PLANNING COMMISSION MEETING AGENDA REGULAR MEETING

PRELIMINARY SITE PLAN REVIEW (SU JPLN2023-0001) - Proposed New Tower Troy, Office Building and Parking Deck, East side of Troy Center Drive, South of Big Beaver, 755 Big Beaver Road (PIN 88-20-28-101-067), Section 28, Currently Zoned BB (Big Beaver) District

Re: New Tower, 755 W. Big Beaver Rd Preliminary Site Plan Review

NEW TOWER TROY

Proposed Parking Structure & Retail Elevations

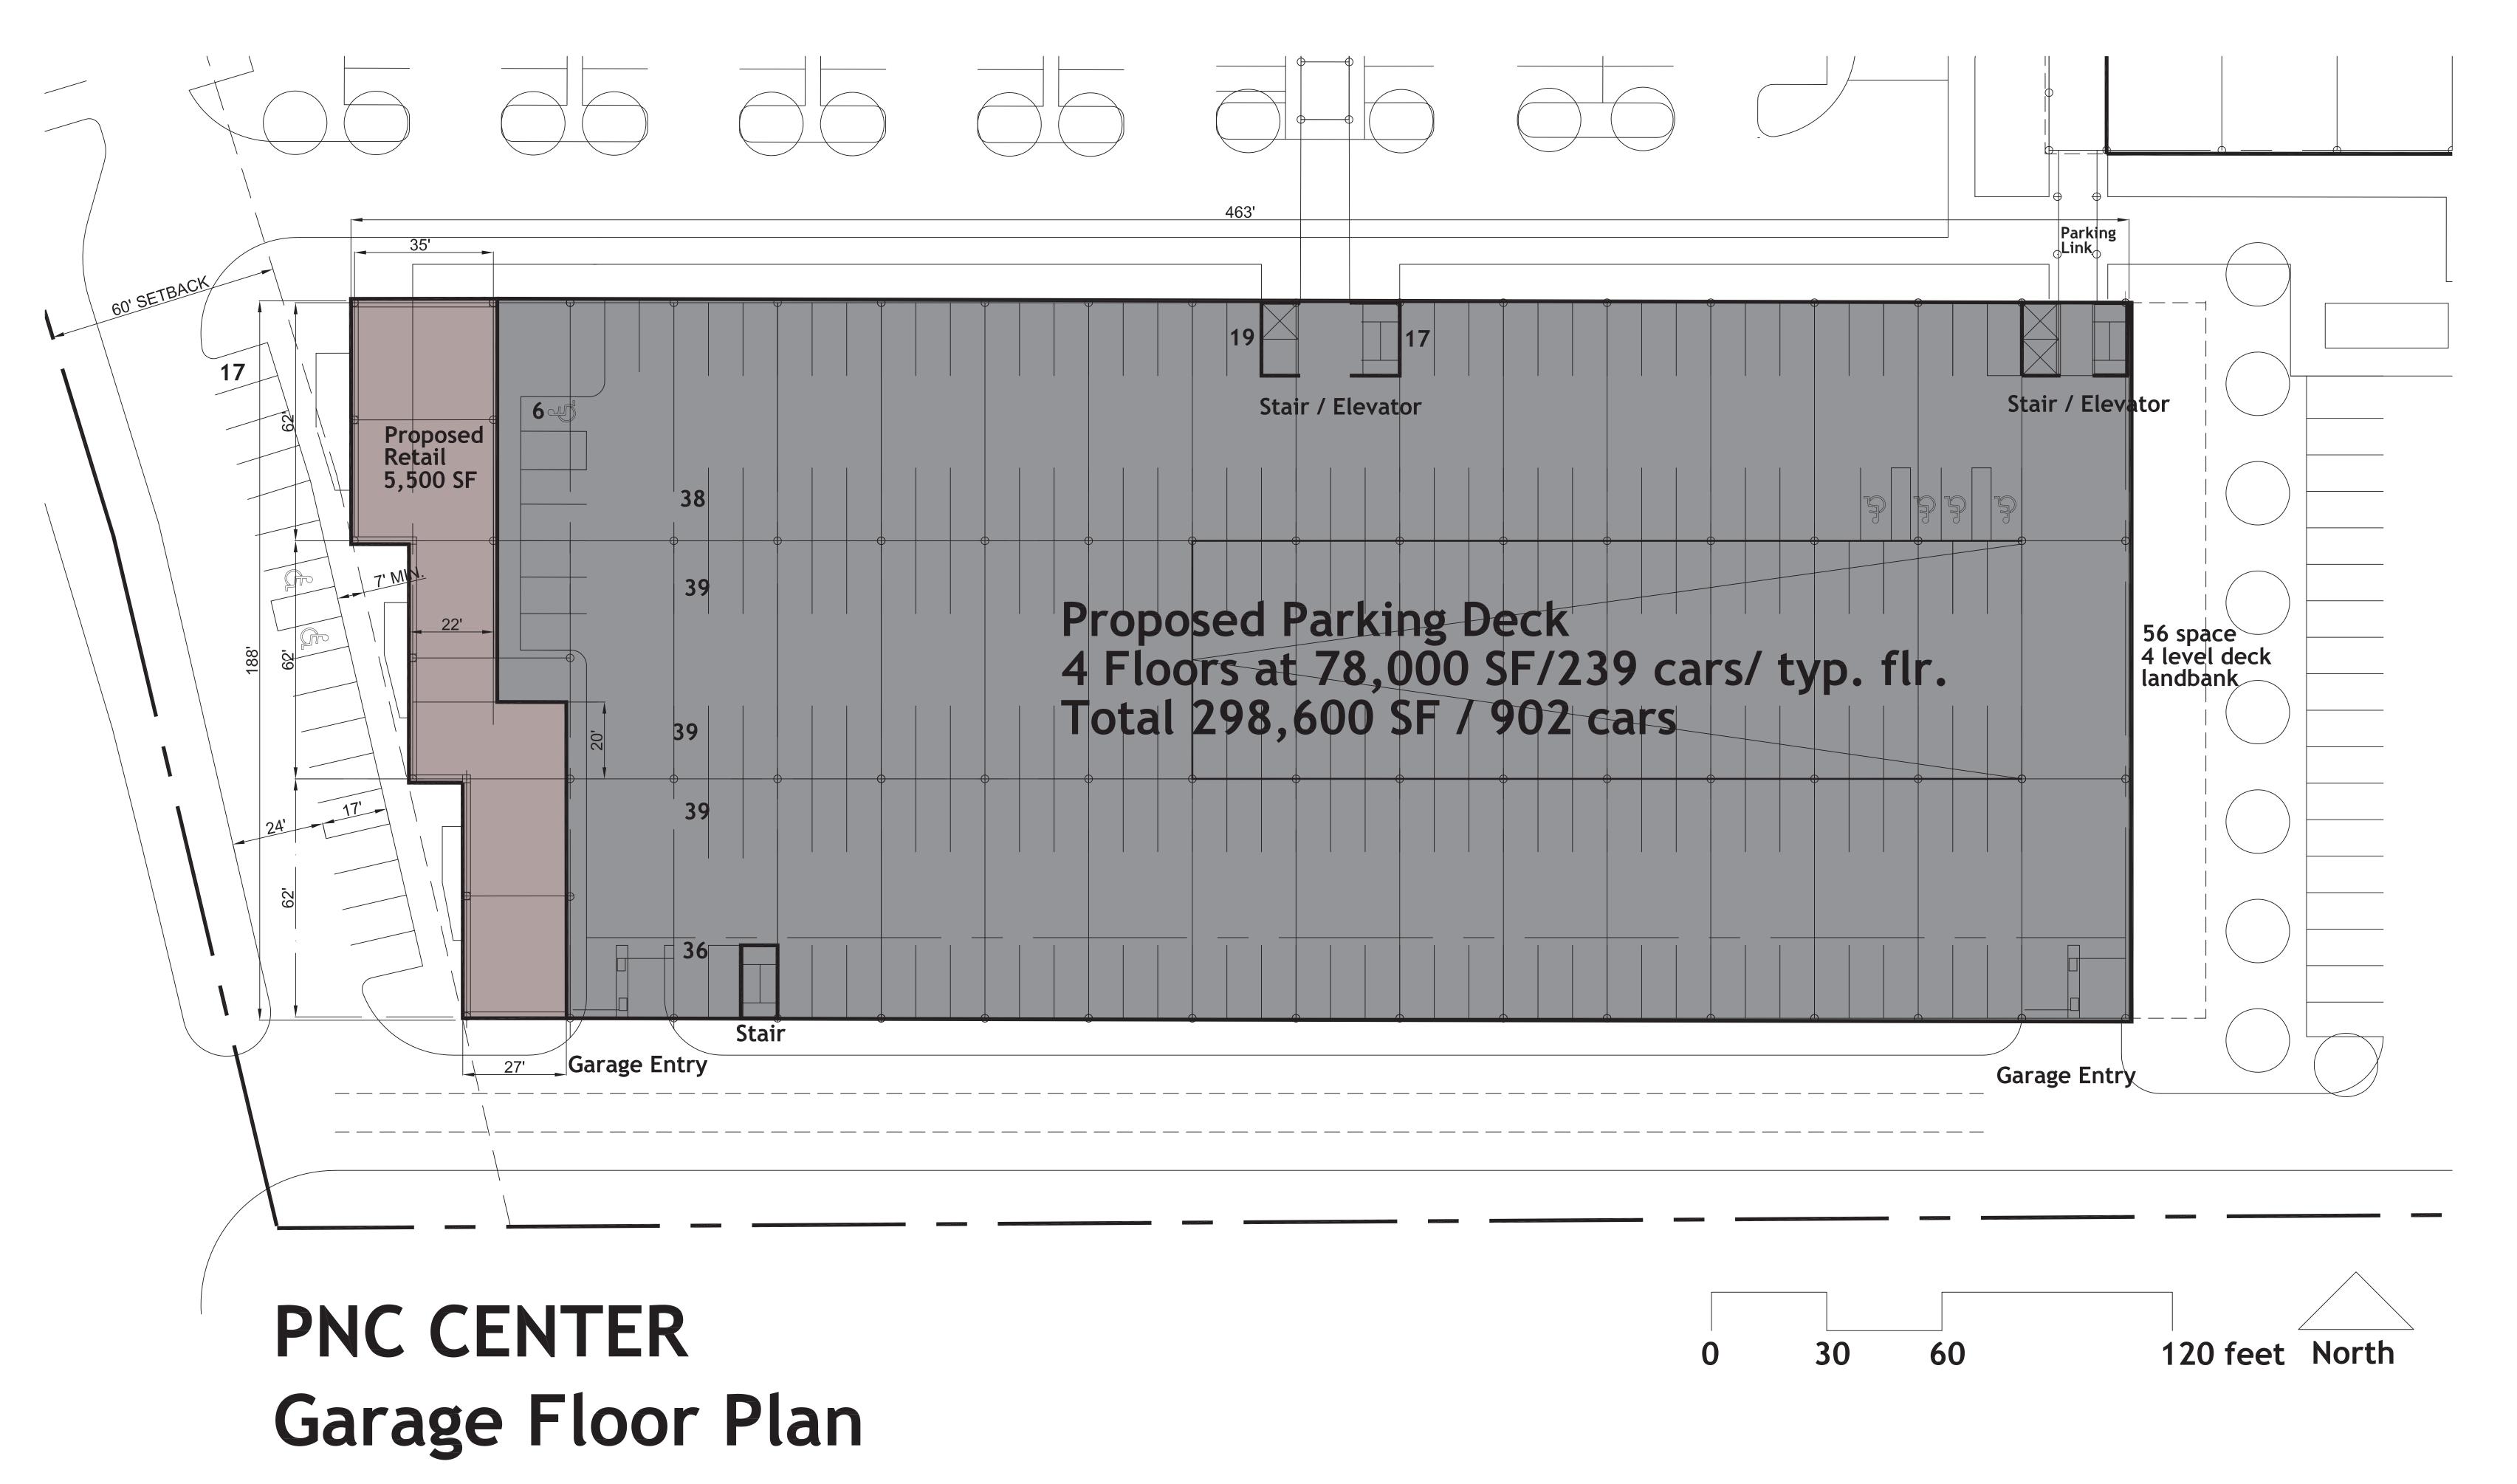
The elevations of the parking structure show that the façade has stained structural precast concrete to match the office building. The parking structure appears to lack much architectural detail. Adding additional architectural details to the parking structure should be considered.
